2. **Resolution No. 449. Twist Bioscience Storage Buildings.**

**DEVELOPMENT REVIEW BOARD  
RESOLUTION NO. 449**

Exhibit A1  
Staff Report  
Wilsonville Planning Division  
Twist Bioscience Storage Buildings  
Development Review Board Panel 'B'  
Quasi-Judicial Public Hearing

| <b>Application No.:</b>                | DB25-0008 Twist Bioscience Storage Buildings                                                                                                                      |

PROPOSED FENCE TO MATCH EXISTING  
6' HIGH WITH PRIVACY SLATS

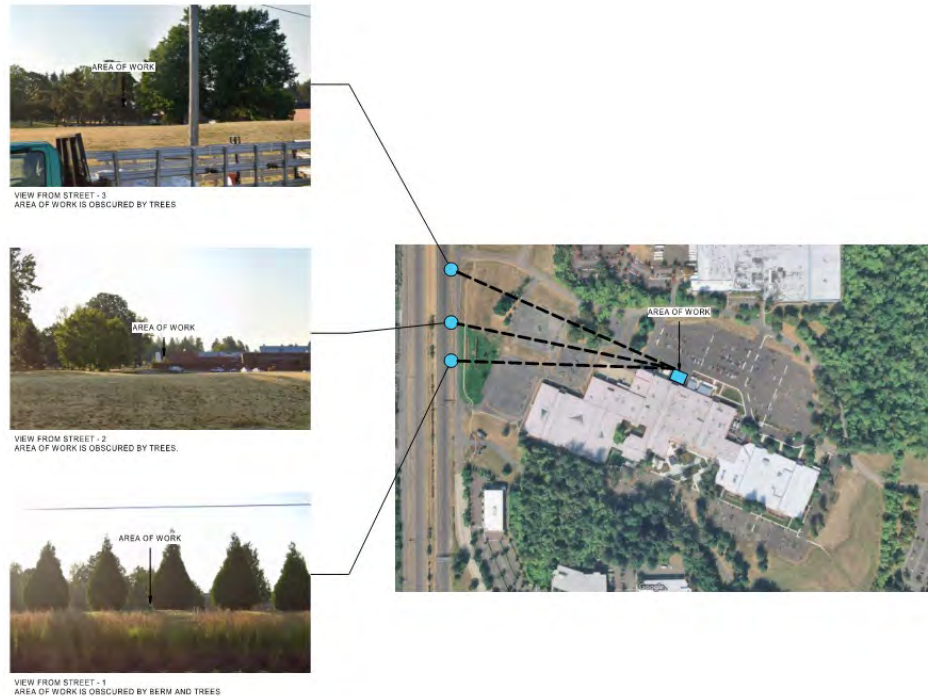
**Partially Sight-Obscuring Fence Standard:** The applicant proposes a six-foot, chain link fence with black privacy slats meeting the partially sight-obscuring fence standard along the proposed storage buildings and around the proposed loading area (Exhibit B2, Sheet A1.11). The proposed fence matches the existing, partially sight-obscuring fence around the adjacent outdoor storage yard.
